REMOVAL OF HALON 1301 CYLINDER FROM THE RADAR DATA ACQUISITION (RDA) SHELTER

DOPPLER METEOROLOGICAL RADAR WSR-88D

Issuance Number: EHB 6-00-01
Data Code: 3118587
Issuance Date: 16 March 2000
DoD/NWS Rescission Date: 1 April 2001

This document provides instructions to remove the Halon 1301 cylinder from the RDA equipment shelter for environmental reasons. The authority for this document is Operational Support Facility (OSF) Engineering Change Proposal (ECP) F0128, Halon Removal.

Figure 1 Halon 1301 Cylinder

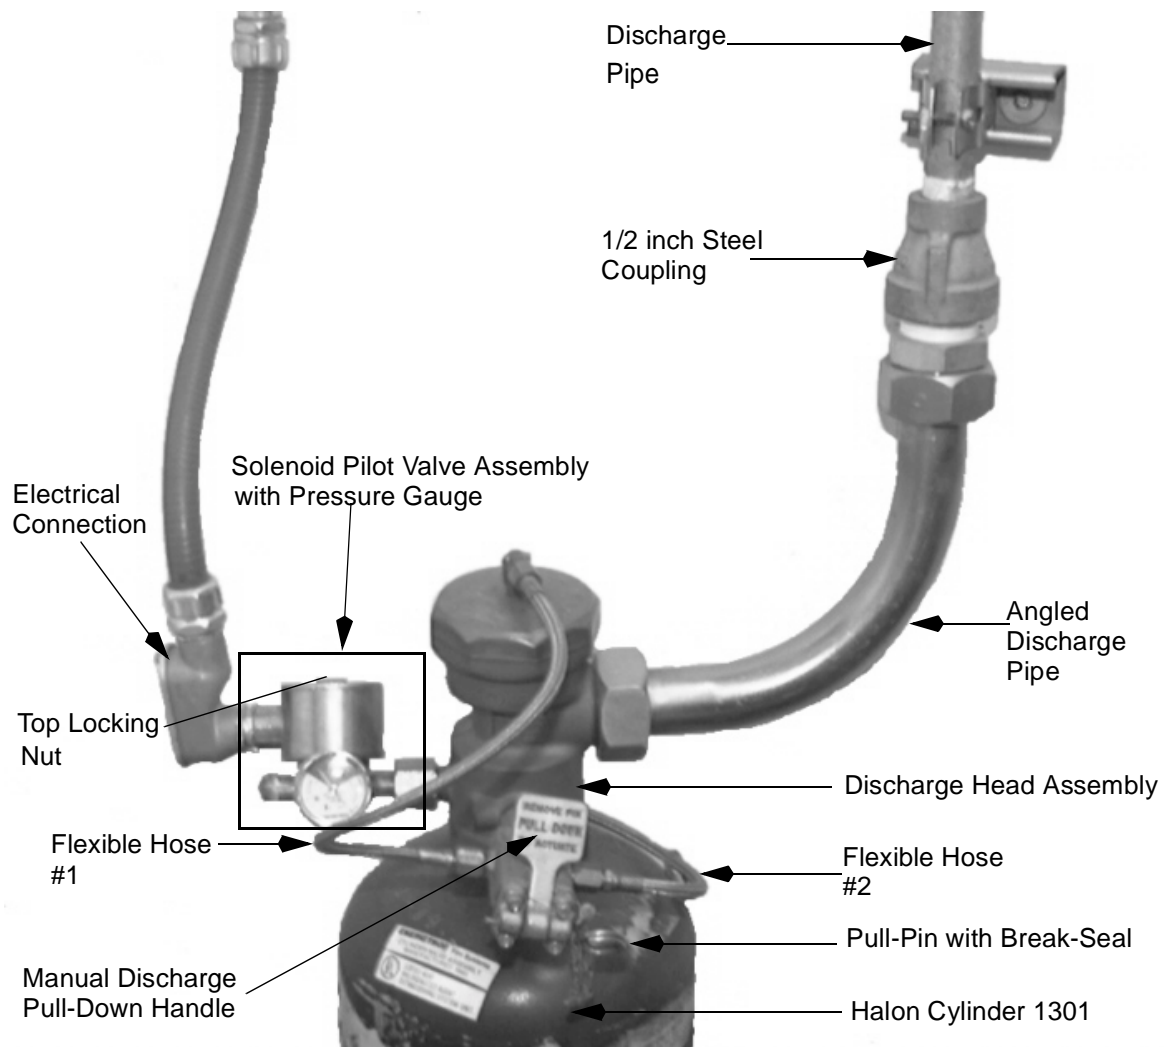
1. On the RDA Main Power Distribution Panel UD7A2, set the Halon panel circuit breaker CB20 to the **OFF** position. Verify the message EQUIPMENT SHELTER HALON/DETECT SYS FAULT appears at the RDA Man Machine Interface (MMI).
2. Using an adjustable wrench, remove the top locking nut on the Solenoid Pilot Valve Assembly. (See [Figure 1](#))
3. Carefully lift the Solenoid Pilot Valve Assembly off of the Pressure Gauge so as not to loose any parts.
4. Using a tiewrap, secure all of the Solenoid Pilot Valve Assembly together.
5. Using a pipe wrench, disconnect the Angled Discharge Pipe from the Discharge Head Assembly, then loosen the coupling nut at the top portion of the Angled Discharge Pipe. Swing the Angled Discharge Pipe away from the Discharge Head Assembly (See [Figure 1](#).)

6. Using a 9/16 inch combination wrench, remove the fasteners from around the Halon Cylinder and remove the Halon Cylinder.

Figure 2 Mico 1-EV Control Panel Jumper

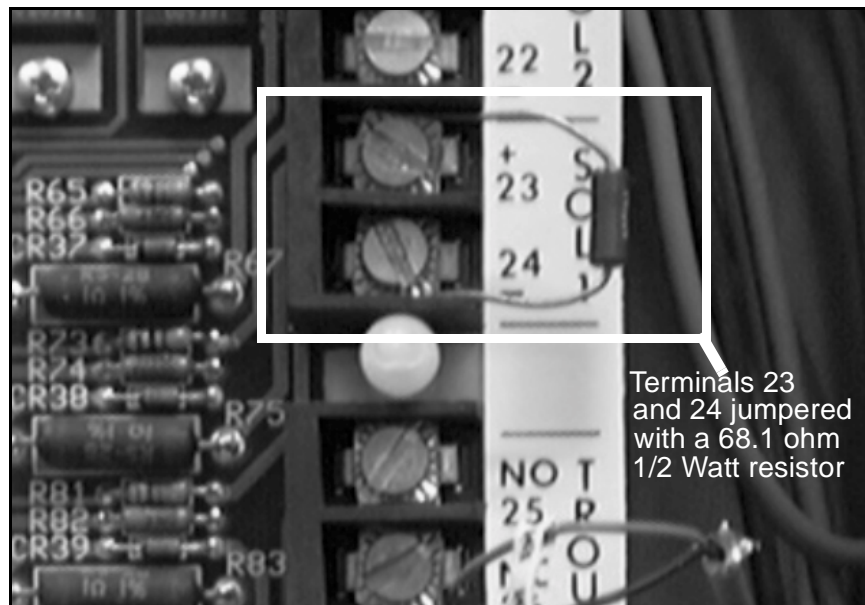
7. Inside the Micro 1-EV control panel, disconnect, isolate and tie back the two solenoid leads on terminals 23 and 24, which are labeled SOL 1. (See [Figure 2](#).)
8. Install the 68.1 ohm, ½ watt resistor (5905-01-178-8949) across terminals 23 and 24. (See [Figure 2](#).)
9. Restore power at the RDA Main Power Distribution Panel, by setting circuit breaker CB20 to the **ON** position.
